KOSMOS Review Panel Response

The KOSMOS Design Review was held August 2-3, 2010 at OSU, with presentations from OSU and NOAO project participants. The review panel provided us with an initial de-brief, followed soon thereafter by a written report. This document contains the project team's response to the recommendations of the written report.

Figure 1: Resolution vs. wavelength for a VPH grism with peak efficiency at 450nm. The lower curve is for a 1 arcsec slit and the upper curve is for a 2-pixel slit. These calculations include the expected as-built instrumental image quality.

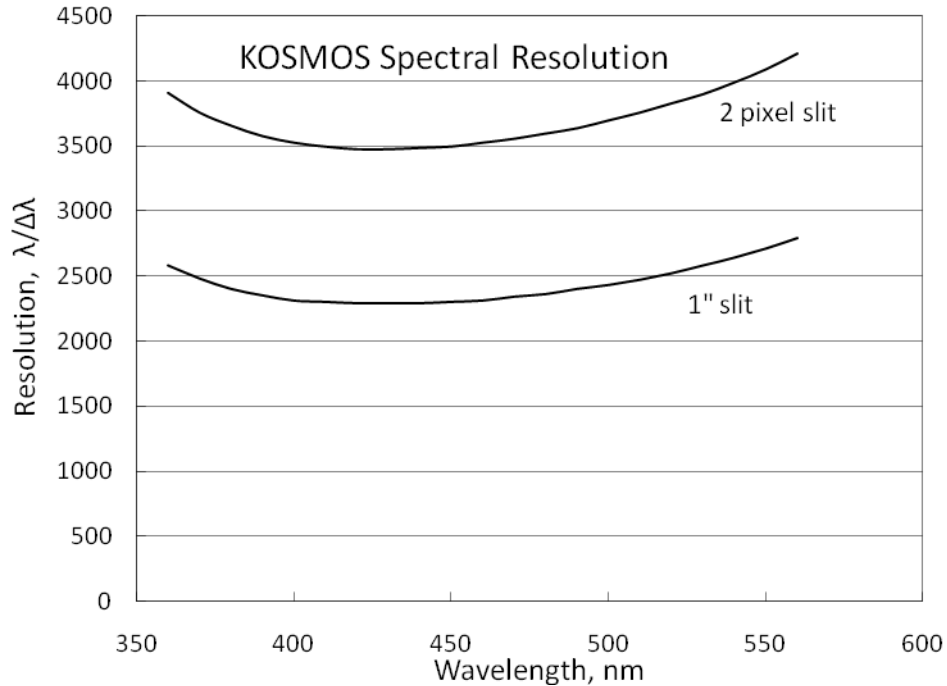
***B. Camera and Collimator Optical design.** A fundamental concern is that the optical design does not meet the spectroscopic resolution or image quality requirements as specified in the FPRD. The final optical design should be described in a report and presentation, which provide sufficient explanation to convince the instrument team and reviewers that the full range of glass choices, surface shapes, and element groupings has been thoroughly considered.*

Response to Finding B: The optical design does meet the spectroscopic resolution and image quality requirements specified in the FPRD. The image quality requirement is specified in subsection 313 of the FPRD. The optical design performance was provided on pg 6 of the KOSMOS Optical Design Document and meets this requirement (see also the response to Panel Finding A).

The design also meets the spectroscopic resolution requirement (subsection 315 in the FPRD) of at least $R=2300$ with a 1" slit, although we acknowledge that this was not clearly communicated to the Panel. A disperser design that demonstrated compliance was only completed immediately before the review and consequently was not discussed in the KOSMOS Optical Design Document, although one was mentioned in the presentation slides and shown in more detail in the actual presentation. The figure below illustrates a disperser design that achieves the required performance with a 1" slit. Specifically, the resolution is $R=2300$ from 400 to 450nm and somewhat higher at longer and shorter wavelengths. The performance with a 2-pixel slit is also shown, which demonstrates that higher resolutions can be achieved with slits as narrow as 2-pixels.

The resolution is defined to be $\lambda/\Delta\lambda$, where $\Delta\lambda$ corresponds to the FWHM of a single wavelength that has been convolved with a pair of Gaussians that represent the slit and the instrumental image quality. The slit was approximated by a Gaussian with FWHM = 1" (or 2-pixels for the upper curve) to represent a stellar object, while the instrumental image quality was approximated by a Gaussian with FWHM = 0.5". Both of these assumptions are fairly conservative. The first is conservative because apodization by the slit (e.g. use of a square slit function) will decrease the width if the slit is matched to atmospheric seeing, while the second represents the worst-case image quality at the edge of the detector for the expected as-built performance, that is including random fabrication and assembly errors. As noted in the KOSMOS Optical Design Document and the response to Finding A, the image quality is <0.25" or better over the imaging FOV. We note that we did not use the Rayleigh criterion, as recommended in Finding G below, because that measure is appropriate for diffraction-limited optical systems.

The VPH grism design used for this calculation is comprised of a grating with 1560 lines per mm that is sandwiched between two 30 degree Ohara PBM2Y prisms. The spectral coverage on the CCD is 360-558 nm. A blue-optimized design was chosen for this demonstration because this proved to be the most challenging wavelength regime in which to meet the requirement. Higher index materials than PBM2Y ($n=1.64$ at 450nm), such as N-LAK34 ($n=1.74$) and N-SF11 ($n=1.82$), would allow higher line densities and consequently higher resolutions, but blue transmission generally decreases for higher index glasses. These materials can be employed for grisms optimized for longer wavelengths and consequently make it easier to meet the resolution requirements at redder wavelengths.
